# STRATHFIELD LOCAL PLANNING PANEL MEETING AGENDA

**TO:** Strathfield Local Planning Panel Meeting - 16 May 2024  
**REPORT:** SLPP – Report No. 8  
**SUBJECT:** S8.2-DA2023.111 - 36 BAREENA STREET STRATHFIELD  
**DA NO.** S8.2-DA2023.111 – 36 Bareena Street STRATHFIELD

## SLPP REPORT

Figure 2: Proposed Site Plan

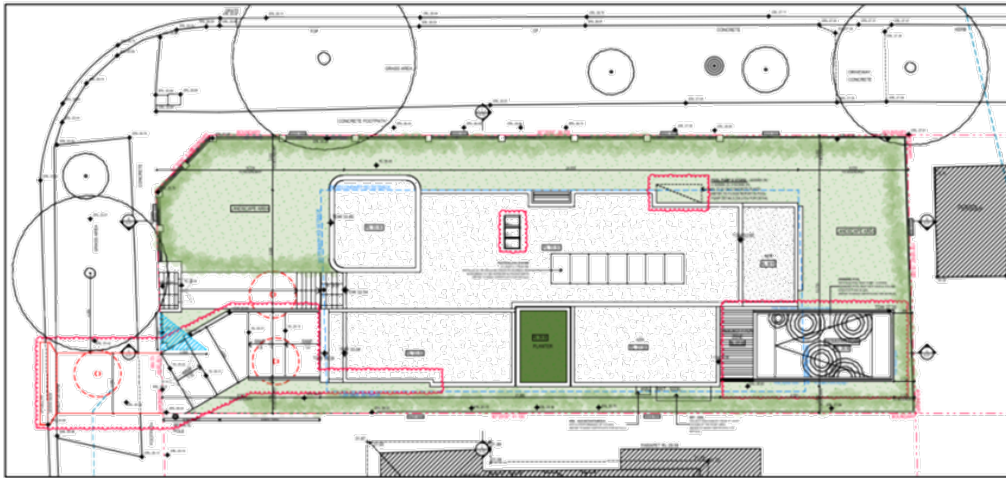
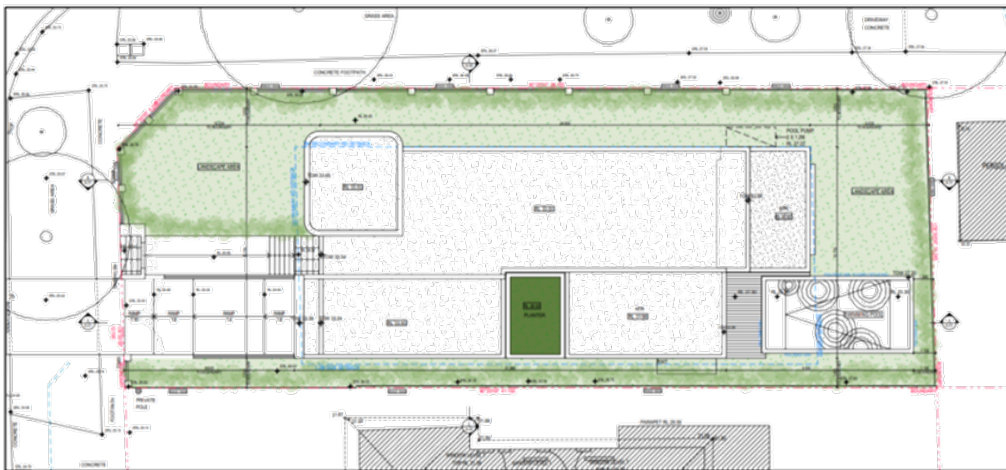
As part of the Section 8.2 application, an updated Arborist Report was submitted and considered acceptable by Council's Tree Management Officer. The amended plans show the driveway has been relocated closer to the southern side boundary to minimize impacts to Tree T4. The relocation of the driveway is considered acceptable by Council's Tree Management Officer.

As discussed above, the impact from the stormwater and service connections and driveway location were not detailed in the Arborist Report and formed a reason for refusal. As part of the Section 8.2 application, an updated Arborist Report was submitted and considered acceptable by Council's Tree Management Officer. The amended plans show the driveway has been relocated closer to the southern side boundary to minimize the impact to Tree T4. The relocation of the driveway is considered acceptable by Council's Tree Management Officer.

The driveway width being 3.8 metres at the property boundary formed reason for refusal of the application. The plans submitted as part of the Section 8.2 application show the width of the driveway at the property boundary has been reduced to 3.3 metres. The proposal is non compliant with Control 8.2.1(2) which requires the width of driveways at the property boundary to be 3m. The non compliance is considered minor being 300mm and the width of the driveway has been supported by Council's Traffic Engineer.

A section of the driveway is proposed to be constructed on the southern side boundary and does not comply with Control 8.2.1(10) which requires a driveway should be set back a minimum of 0.5 metres from side boundaries to provide for landscaping between the driveway and side boundary. The driveway has been located adjacent to the southern side boundary to ensure street tree T4 is not impacted. The non compliance only extends for 2.1 metres and is considered acceptable.

Figure 4: Proposed Basement Plan

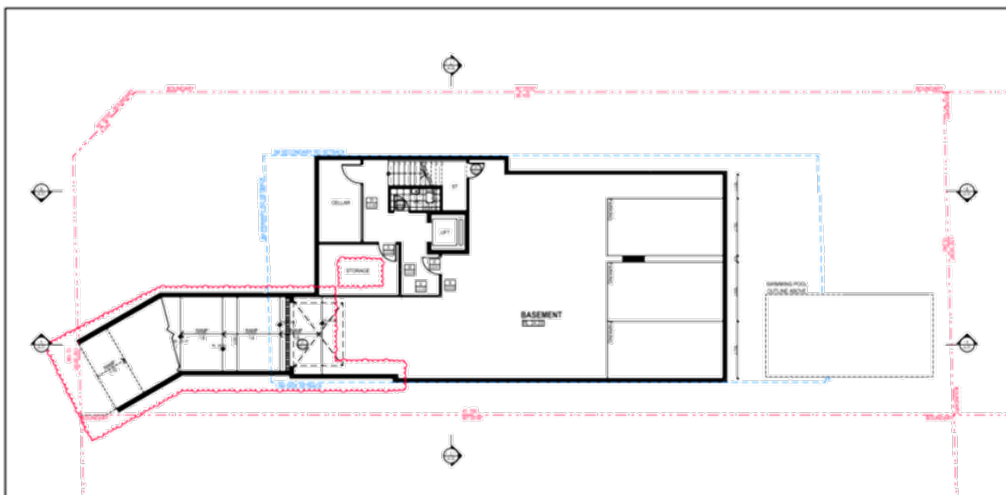
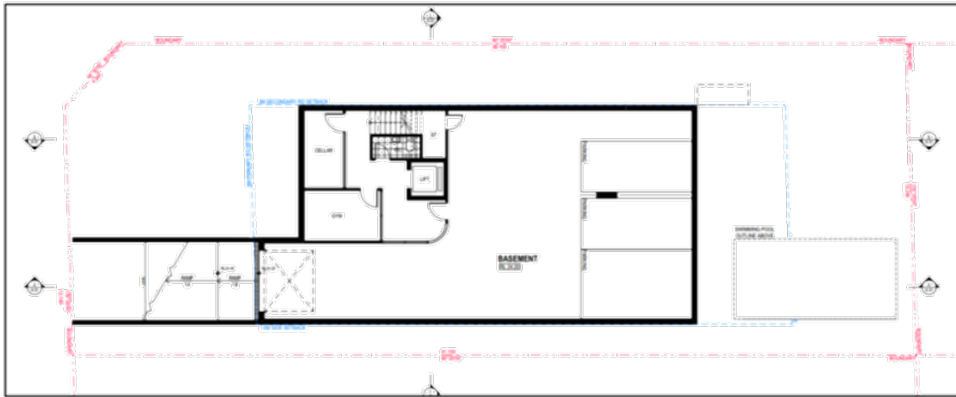
It is noted that the refused development incorporated a basement that extended beyond the ground floor footprint and in combination with bulk and scale above ground, was considered excessive. Therefore excessive excavation formed a reason for refusal. As part of the Section 8.2 application, the proposal has been amended so that the basement is largely contained within the footprint of the dwelling at ground level. A minor section breaches the ground floor footprint where the southern ground floor planter is located. This is considered acceptable as the breach is setback approximately 19.4 metres from the front boundary and will not result in

It is noted that the refused development incorporated a basement that extended beyond the ground floor footprint and in combination with bulk and scale above ground, was considered excessive. Therefore excessive excavation formed a reason for refusal. As part of the Section 8.2 application, the proposal has been amended so that the basement is largely contained within the footprint of the dwelling at ground level. A minor section breaches the ground floor footprint where the southern ground floor planter is located. This is considered acceptable as the breach is setback approximately 19.4 metres from the front boundary and will not result in impacts to the streetscape. The size of the basement is largely contained within the ground floor footprint and is considered acceptable in this regard.

Figure 12: Proposed Ada Avenue (North) Elevation

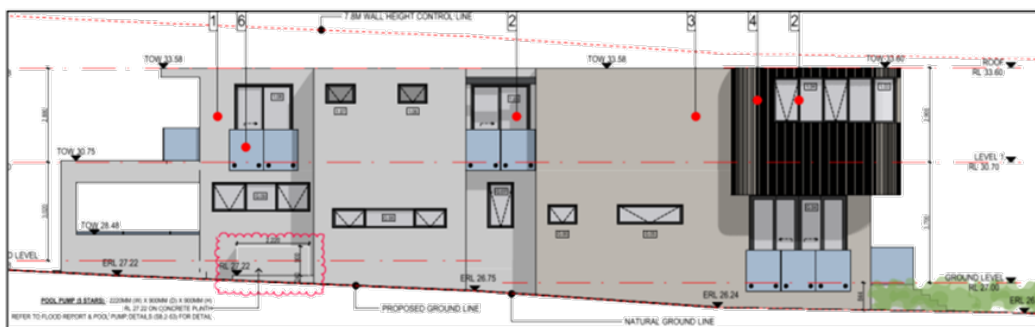
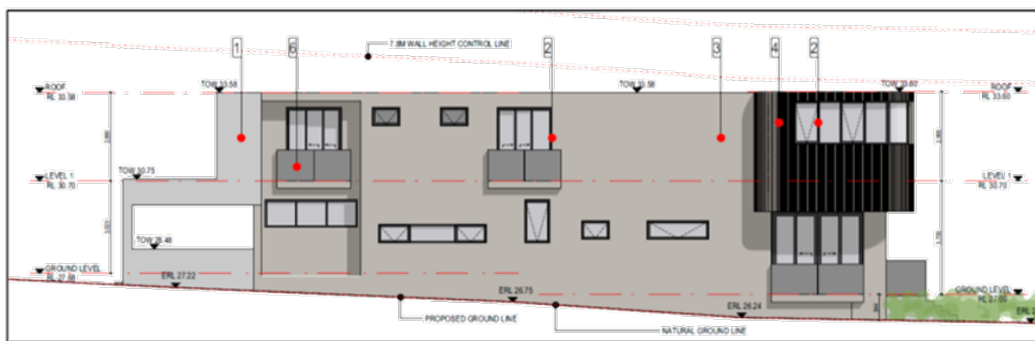
The reasons for refusal include concerns the secondary street frontage presentation to Ada Avenue does not sufficiently address the street. The plans submitted with the Section 8.2 application show improvements to the northern façade with a varied front setback to Ada Avenue, compared to the flat continuous setback in the refused design. The front setback to Ada Avenue now varies from 2.2 metres to 3.7 metres. The varied front setback breaks up the massing and provides visual interest. Also essential to the refusal was the blank wall at the rear of the dwelling sheltering the first floor rear balcony from views to the street. The plans submitted with the Section 8.2 application show the northern wall of the rear facing first floor balcony has been deleted. The deletion of the wall reduces the bulk of the first floor and allows passive surveillance to Ada Avenue.

been amended to provide a varied front setback. The front setback to Ada Avenue varies from 2.2 metres to 3.7 metres. The varied front setback breaks up the massing and provides visual interest. Sufficient windows are proposed to provide street surveillance. The northern wall of the rear facing first floor balcony has been deleted. The deletion of the wall reduces the bulk of the first floor and allows passive surveillance to Ada Avenue. The proposal provides separate pedestrian and vehicle access and is consistent with the access, safety and security controls in the SCDCP 2005.

Figure 16: Proposed South Elevation

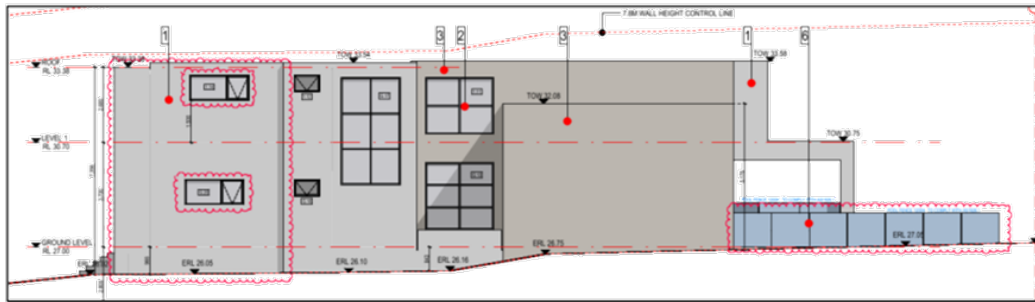
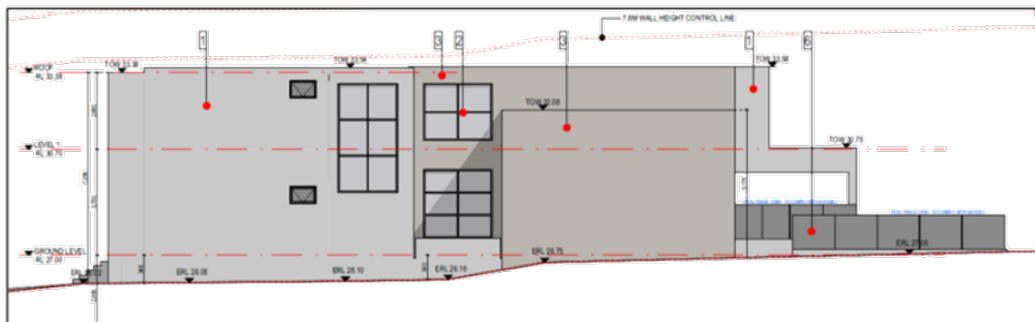
The reasons for refusal include concerns with the blank walls along the southern façade. The plans submitted with the Section 8.2 application show a varied southern side setback is

**Figure 24:** Front setback of guest bedroom balcony notated on ground floor plan

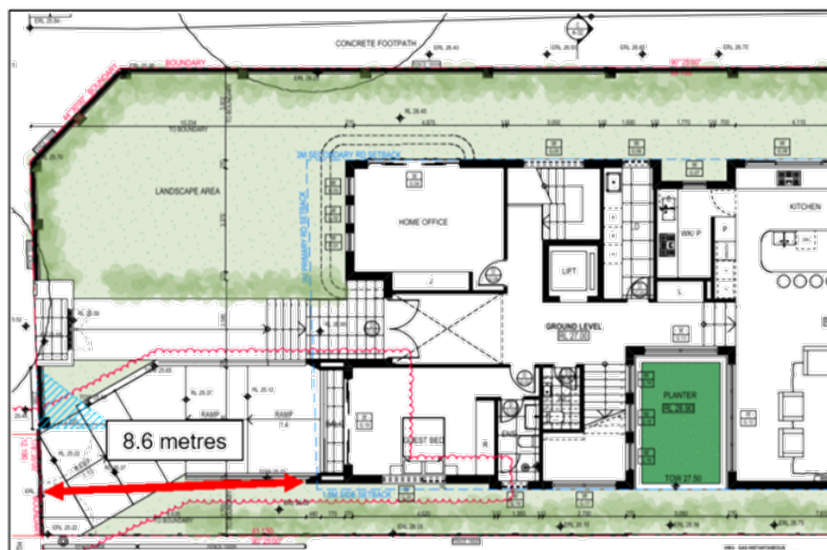
Control 4.2.3.1(1) requires the primary street setback to be 9 metres. The proposal has a front setback of 8.6 metres and does not comply with the control. The non compliance is associated with a section of the guest bedroom balcony (**Figure 24**) and bedroom 3 balcony (**Figure 25**). The non compliance is considered minor being 400mm and is associated with a small section of the balconies. The remainder of the proposal complies with the front setback requirement, including at any point from the main building wall line. The non compliance is considered acceptable in this regard.
